Access Compliance Report Public Rights-of-Way (Curb Ramps)

Main Street: THEODORA_DR **Cross Street:** HOLT_AVE **Location:** NW

ADA ID: RPRK220121122509 **Ramp Type:** Type 4 - Parallel **Initial Pass/Fail:** Fail **Overall Compliance:** No **Severity Score:** 2

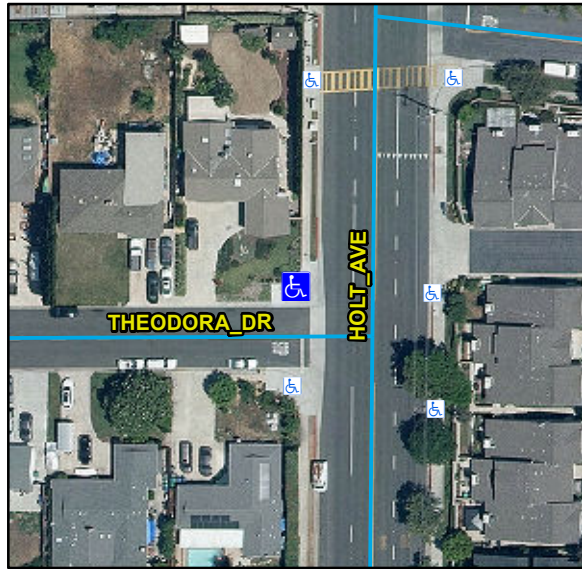
Compliance	Description	Data	Compliance	Description	Data
N/A	Ramp Length LT (in)	89	N/A	Ramp Length RT (in)	90
Yes	Ramp Width LT (in)	102	Yes	Ramp Width RT (in)	102
Yes	Ramp Run Slope LT (%)	4.8	Yes	Ramp Run Slope RT (%)	4.2
No	Ramp Cross Slope LT (%)	2.5	No	Ramp Cross Slope RT (%)	3.7
N/A	Landing Present	N/A	N/A	DWS Provided	N/A
N/A	Landing Length (in)	N/A	N/A	DWS Contrast	N/A
N/A	Landing Width (in)	N/A	N/A	DWS Length (in)	N/A
N/A	Landing Run Slope (%)	N/A	N/A	DWS Full Width	N/A
N/A	Landing Cross Slope (%)	N/A		DWS Offset Type	N/A
N/A	Landing Movement Obstructed?	N/A	N/A	DWS Offset Left (in)	N/A
	Landing Movement Type	N/A	N/A	DWS Offset Right (in)	N/A
N/A	Landing Shared	N/A			
N/A	Clear Space	Yes			
N/A	Clear Space To Crosswalk (in)	N/A			
N/A	Marked Crosswalk 1	No	N/A	Marked Crosswalk 2	No
	Crossing 1 Direction	S		Crossing 2 Direction	E
N/A	Marked Crosswalk 1 Width (in)	N/A	N/A	Marked Crosswalk 2 Width (in)	N/A

N/A	Ramp Inside Crosswalk 1	N/A	N/A	Ramp Inside Crosswalk 2	N/A
	Crossing 1 Slope (%)	3.3		Crossing 2 Slope (%)	8.1
	Crossing 1 Cross Slope (%)	3.3		Crossing 2 Cross Slope (%)	0.7
N/A	Gutter Ponding	N/A	Yes	Curb Slope	6.3
Yes	Gutter Lip Height (in)	0		Road Run Slope (%)	0.8
N/A	Gutter Run Slope (%)	N/A		Road Cross Slope (%)	3
N/A	Gutter Cross Slope (%)	N/A	Yes	Perpendicular Joint Present	Yes
Yes	Overall Surface Condition	Acceptable			
	Cross Gutter Present?	Yes		Spandrel Present?	Yes
	Replace Cross Gutter?	No		Replace Spandrel?	No

Possible Solutions:
Remove & Replace Curb Ramp With Two New Directional Ramps or Equivalent.

OC Std/PROW:
 R304.5.3, STD 1115
